INDIANA DEPARTMENT OF TRANSPORTATION

APPROVED MINUTES

December 17, 2015 Standards Committee Meeting

RE: Minutes from the December 17, 2015 Standards Committee Meeting

SINGLE LANE CLOSURE

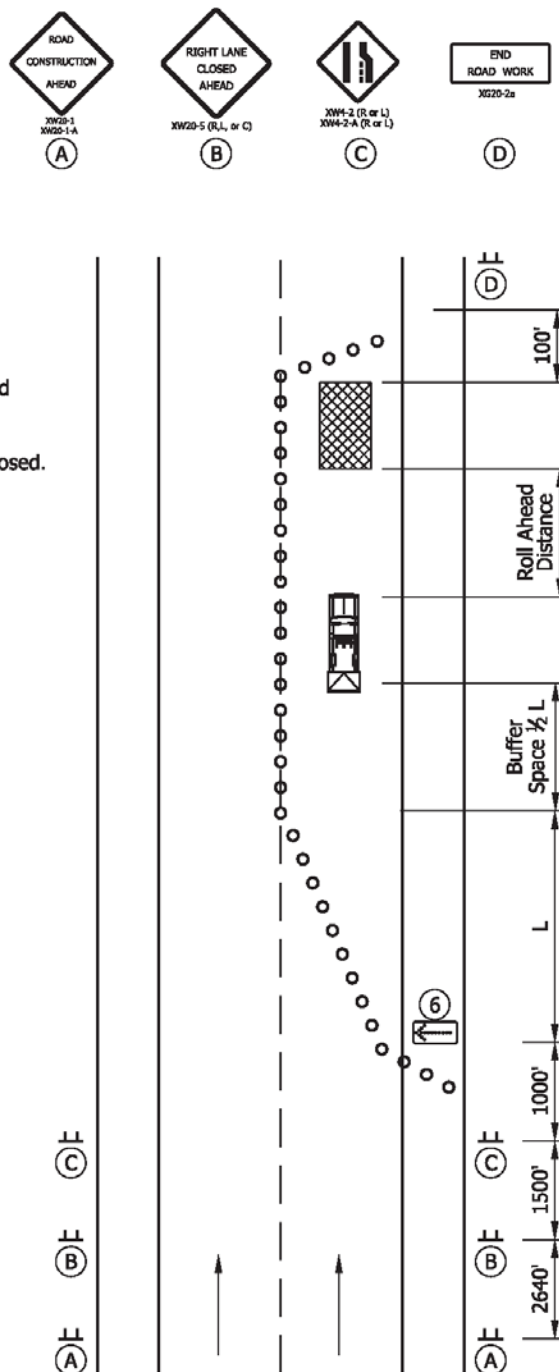
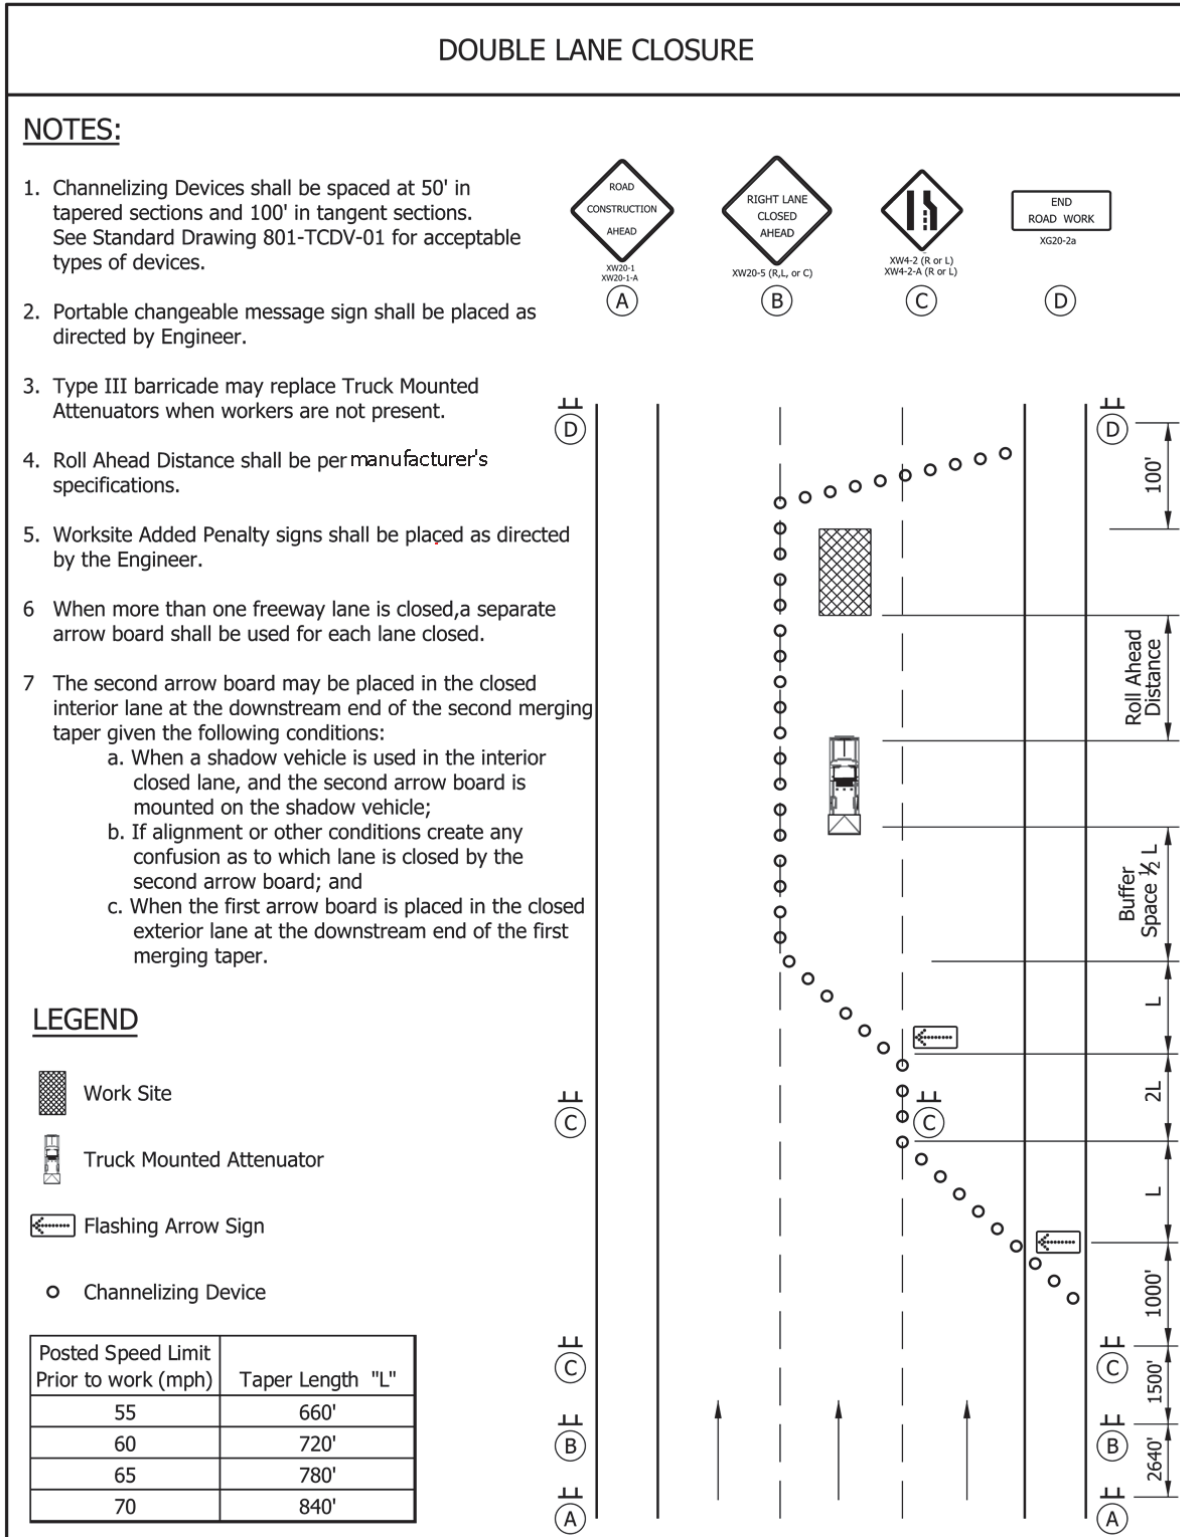
~~The Contractor shall provide additional shadow vehicles~~ An additional shadow vehicle shall be provided for any gaps in the operation of 500 ft or more.

TMA units shall be maintained in such a manner as to provide continuous service. ~~Where a unit becomes inoperable, work shall be suspended until the unit is repaired or replaced.~~ No time extension will be considered for delays due to inoperable units.

IDM FIGURE 83-5A TYPICAL TEMPORARY SIGNAL VEHICLE DETECTION AREAS
(REVISED DRAFT)

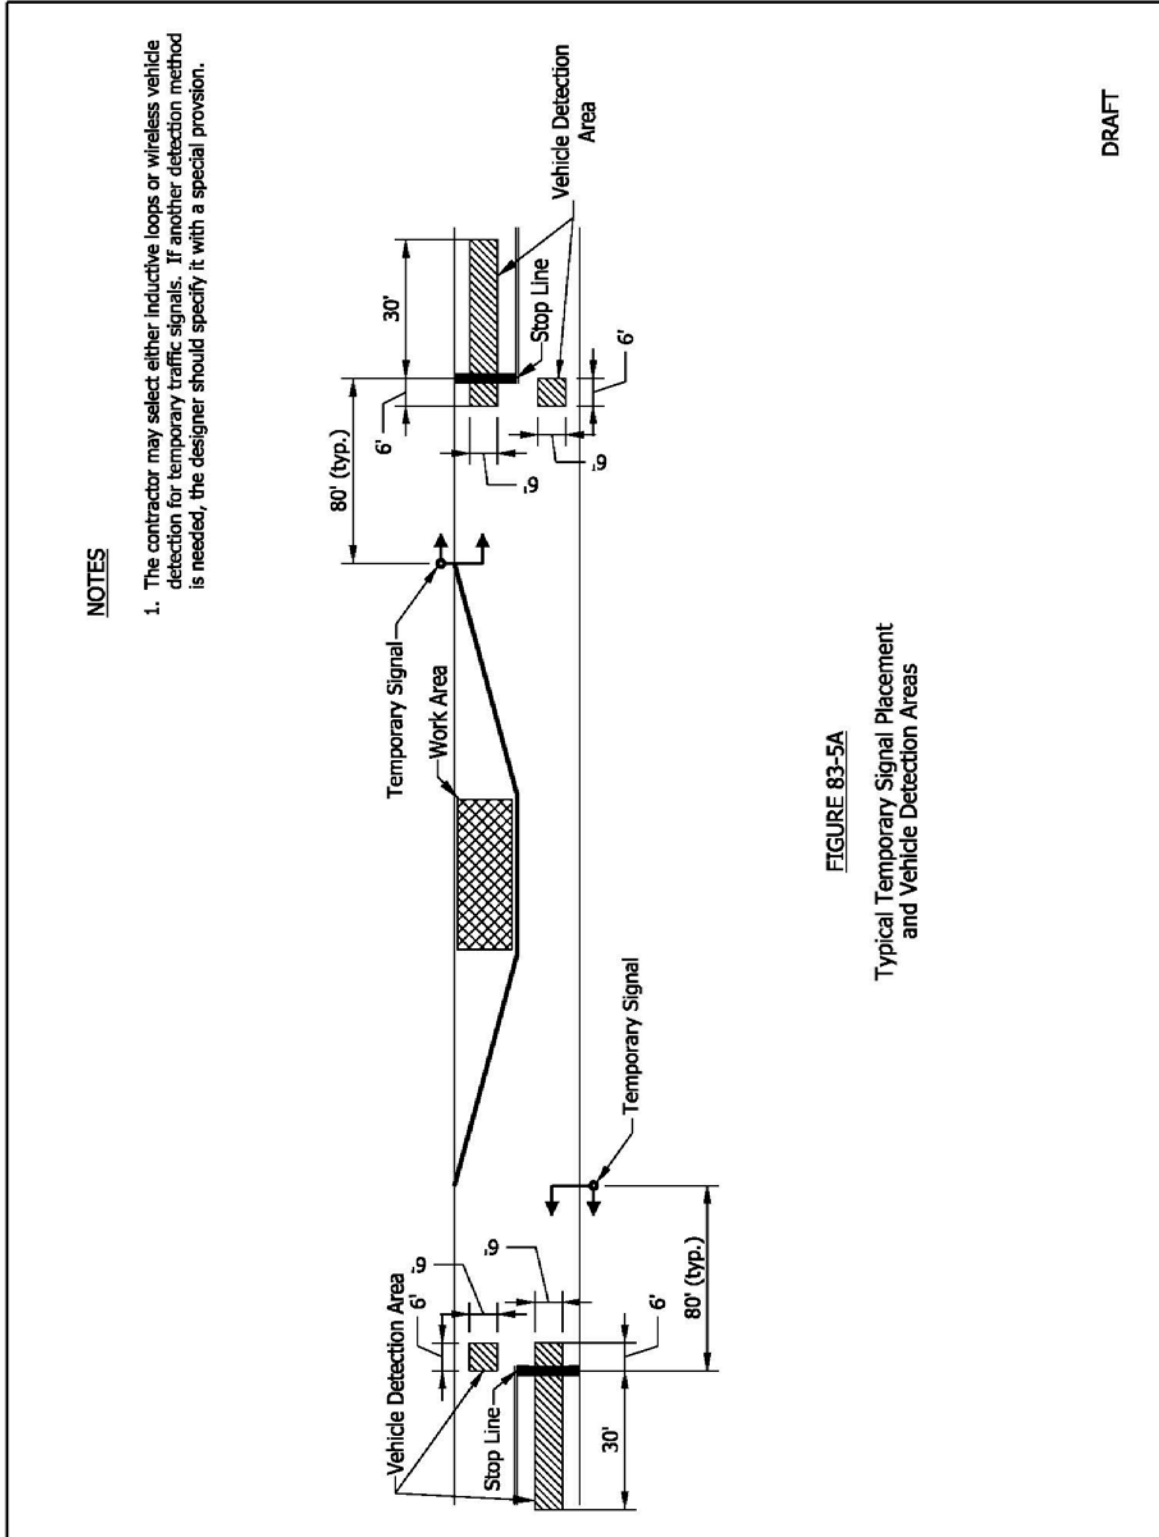
shown on the plans. Figure 83-5A shows typical placement areas. In accordance with the Standard Specifications, the Contractor may use either inductive loop or wireless detection for fixed temporary signals, but only wireless for portable. Should it be determined that another type of detection is needed, a unique special provision should be included in the contract.

- i. Actuation should be provided and shown on the plans- see Figure 83-5A.
 - ii. The minimum green time for both phases is based on driver expectation and may be set at 15 seconds for major arterials regardless of speed and 10 seconds for minor arterials or collectors. The Signal Timing Manual allows for lower values based on engineering judgment (see Table 5-3).

Details regarding detection were accomplished by Mr. Trammell, Ms. Phillips and Mr. Boruff outside this meeting and are shown in these minutes. Motion was revised and seconded.
